FPL Energy
Seabrook Station

SBK-L-06119

**Relaxation Request from the First Revised NRC Order EA-03-009 Regarding
Requirements for Nondestructive Examination of Nozzles Below the J-Groove**

FPL ENERGY SEABROOK RELAXATION REQUEST FROM THE FIRST REVISED NRC ORDER EA-03-009 REGARDING REQUIREMENTS FOR NONDESTRUCTIVE EXAMINATION OF NOZZLES BELOW THE J-GROOVE WELD

Figure 1

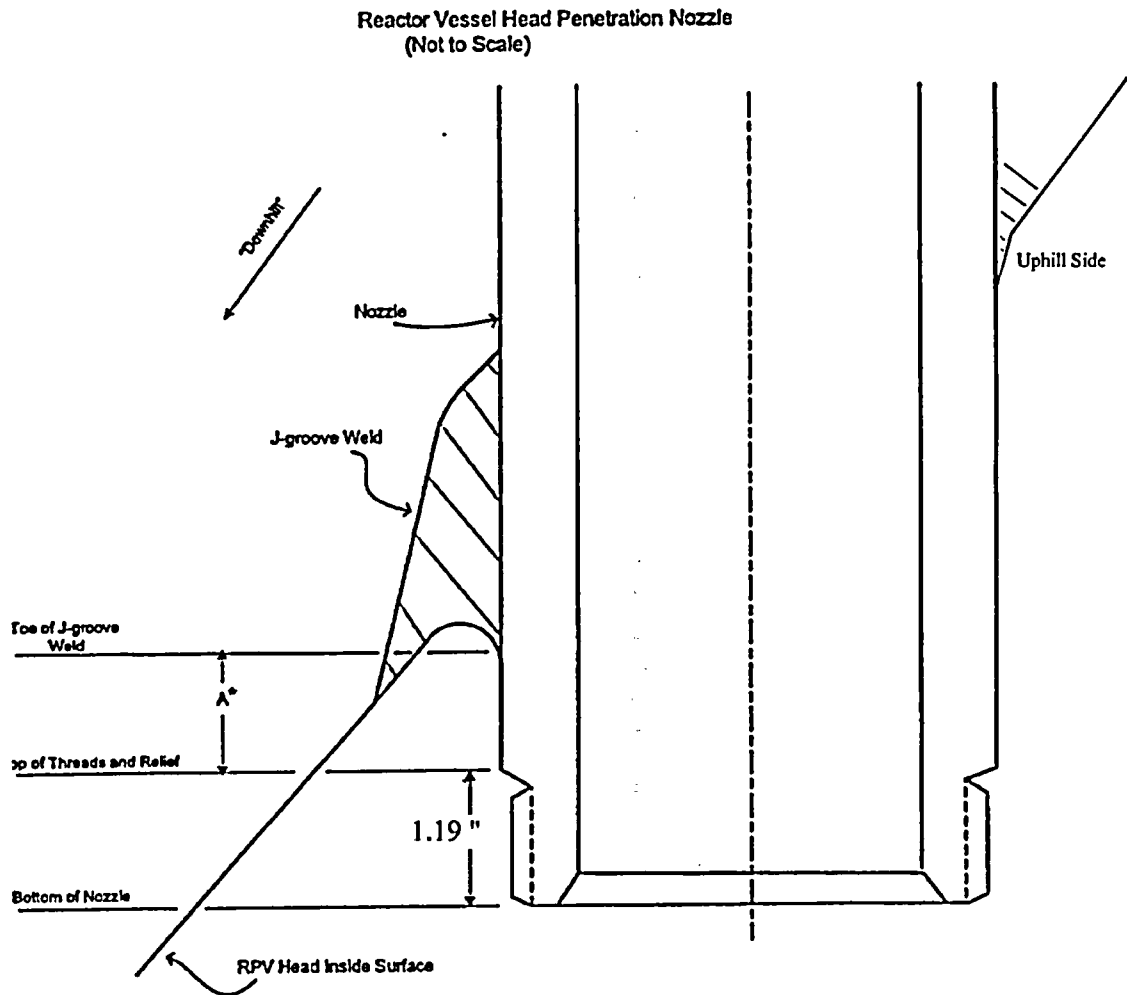
The design of RPV head penetration nozzles 74 through 78, referred to as Type "X", (Figure 1 and Figure 2) includes a threaded section, approximately 1.19 inch in length at the bottom of the nozzles. These penetrations are located at the 48.7 degree location. The dimensional configuration at this location is such that the distance from the lowest point at the toe of the J-groove weld to the top of the threaded region is less than the 1-inch lower boundary limit specified in IV.C.5 (b)(i) and IV.C.5 (b)(ii) of the First Revised Order.

The design of RPV head penetration nozzles 74 through 78 (Figures 1 and 2) includes a threaded section, approximately 1.19-inch length at the bottom of the nozzles. These penetrations are located at the 48.7 degree location. The dimensional configuration at this location is such that the distance from the lowest point at the toe of the J-groove weld to the top of the threaded region is potentially less than the 1-inch lower boundary limit specified in IV.C.5 (b)(i) and IV.C.5 (b)(ii) of the First Revised Order. Therefore, FPL Energy Seabrook anticipates not being able to completely comply with the requirements for UT inspection below the J-groove weld, due to the physical

configuration of the nozzles. Loss of UT probe coupling due to the internal taper and/or the disruption of the UT signal due to the external thread will prevent UT data acquisition from the ID and the threads on the OD. FPL Energy Seabrook proposes that the lower boundary of the Ultrasonic inspection extend to the maximum extent possible but not less than 0.30 inches from the toe of the J-groove weld on the downhill side (figure 5). The actual distance between the toe of the weld on the downhill side and the thread relief is not known for Unit 1. However, measurements made on the Unit 2 head shows that the dimension varies between 0.25 inches and 0.75 inches.

* The distance "A" on penetrations 74,75, 76, 77, and 78 may vary between 0.25" and 0.75 inches based on measurements taken in the Unit 2 RPV head. Actual measurements for Unit 1 have not been made.

From 2 inches above the highest point of the root of the J-groove weld (on a horizontal plane perpendicular to the nozzle axis) to the maximum extent practical but not less than 0.30 inches below the lowest point at the toe of the J-Groove weld (on a horizontal plane perpendicular to the nozzle axis) and including all RPV head penetration nozzle surfaces below the J-

Figure 2

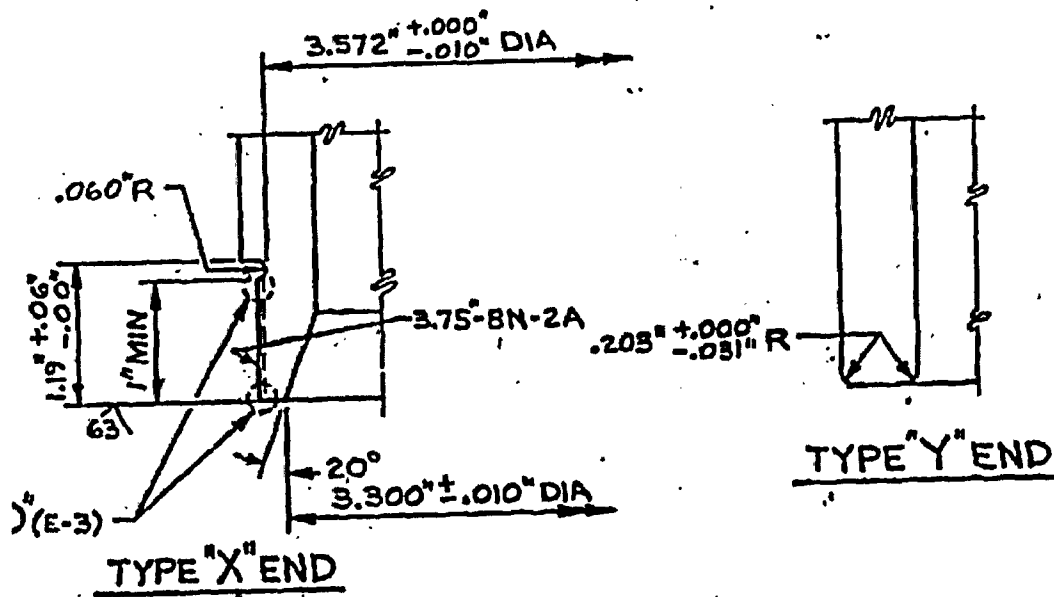
The Reactor Vessel Head CRDM Penetrations at Seabrook have two styles of ends, referred to as Type "X" and Type "Y" (Figure 2). Penetrations 1

through 73 are Type "Y" that are essentially a smooth wall cylinder with a 0.203 radius at the outer diameter and inner diameter. Penetrations 74 through 78 have a threaded outside diameter and an internal taper.

Figure 3

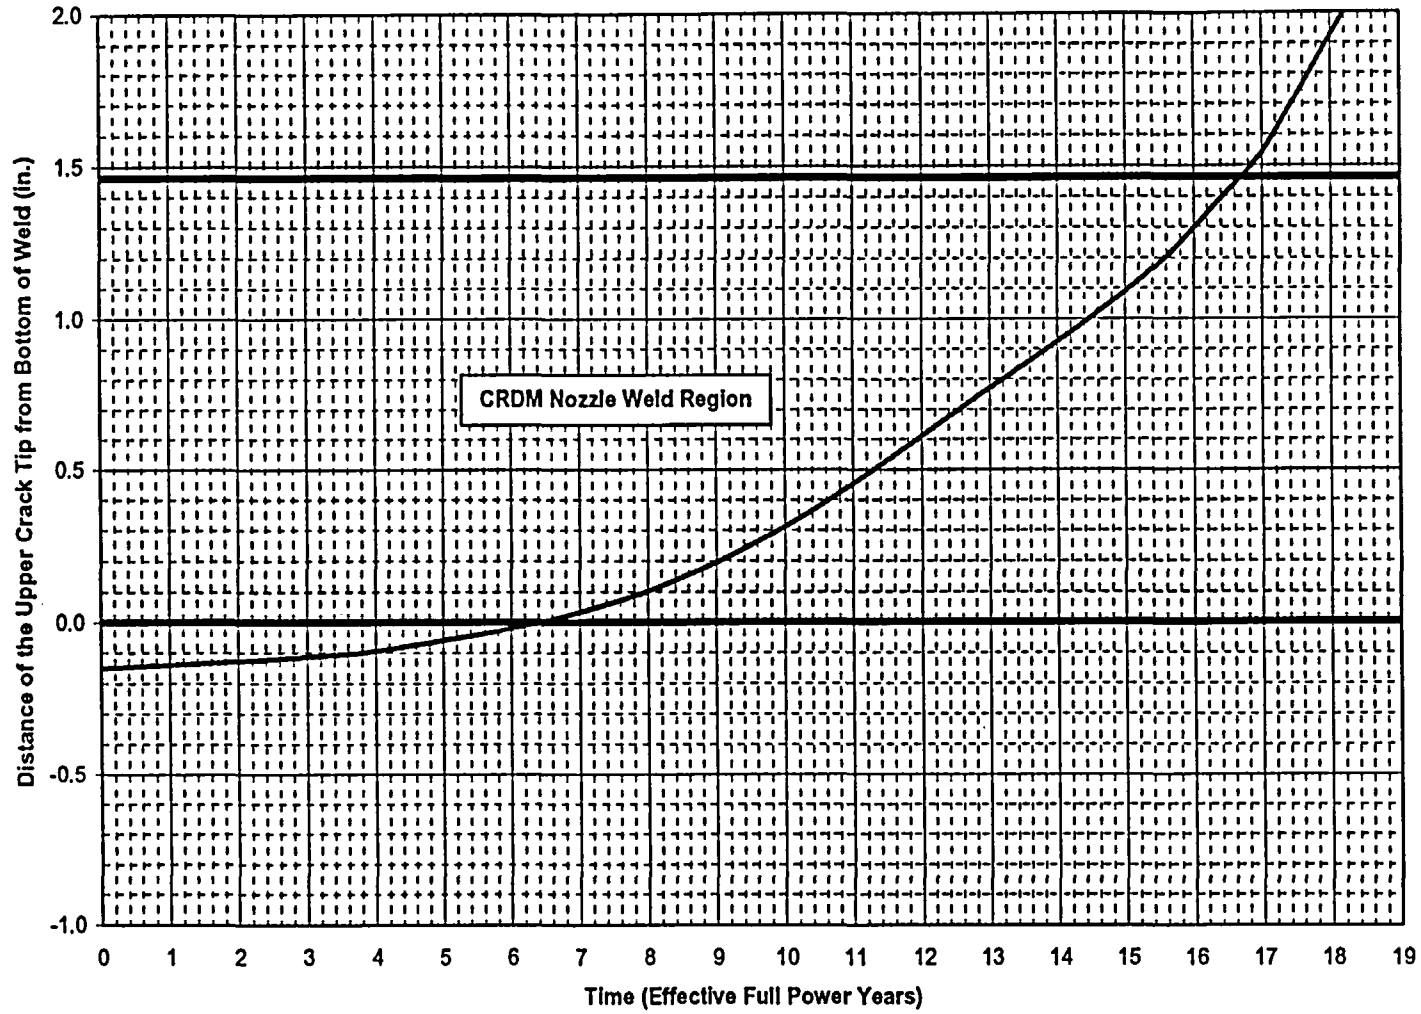
To support the submittal of the relaxation request, in the event that the required 1 inch inspection coverage below the weld cannot be achieved, a series of operational stress plots and axial through-wall crack growth charts for below the weld on the downhill side were prepared using a flaw tolerance approach². The plots for the 48.7 degree penetrations applicable to this relaxation request are shown in Figures 3 and 4. Figure 4 shows the distance below the weld on the downhill side at which the stresses drop below 20 ksi. The distance on the ID surface is at the weld toe and the distance on the OD surface is at 0.30 inches. Therefore, examination to a minimum of 0.30 inches below the weld for these penetrations would satisfy the 20 ksi stress criteria of the Order, thereby minimizing the potential for cracking to exist in the un-inspected areas of the nozzle.

The time duration required for the upper extremity of a postulated axial through-wall flaw to reach the bottom of the weld can be determined from Figure 3. For example, for CRDM nozzles 74 through 78, a axial through wall flaw that has its upper extremity located at 0.15 inches below the weld would take over 6 effective full power years to reach the weld. The results of the flaw propagation calculation indicate that, even if a through wall axial flaw were to occur in the region of the penetration nozzle not being inspected, there would be adequate opportunity for crack detection in the subsequent inspection, per the frequency stated in the Order, prior to reaching the RCS pressure boundary. If a circumferential flaw were to occur in the region of the nozzle that is not inspected, it is not a safety concern since it would not result in pressure boundary leakage.

Figure 5

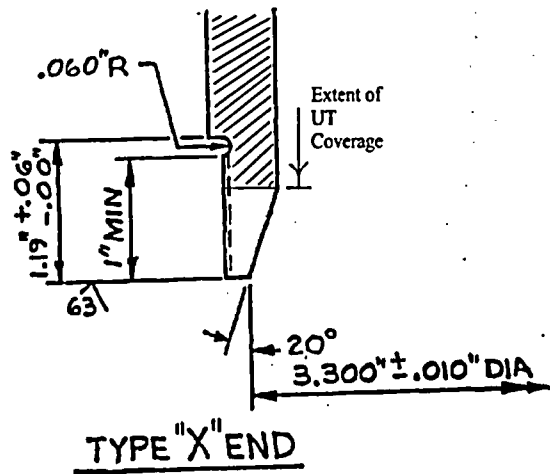
It is FPL Energy Seabrook's intent to perform the examination to the maximum extent possible for all penetrations. FPL Energy Seabrook will achieve examination coverage from two inches above the J-Groove weld down to the lowest elevation that can be practically examined with the Open Housing Probe, as shown in Figure 5, but not less than 0.30 inches below the toe of the weld on the downhill side for penetrations 74 through 78. If examination coverage can not be achieved for Penetrations 1 through 73, FPL Energy Seabrook will submit a relaxation request for those penetrations.

The shaded area shows the extent of the nozzle end that would be inspected for axial indications with the Open Housing Probe.
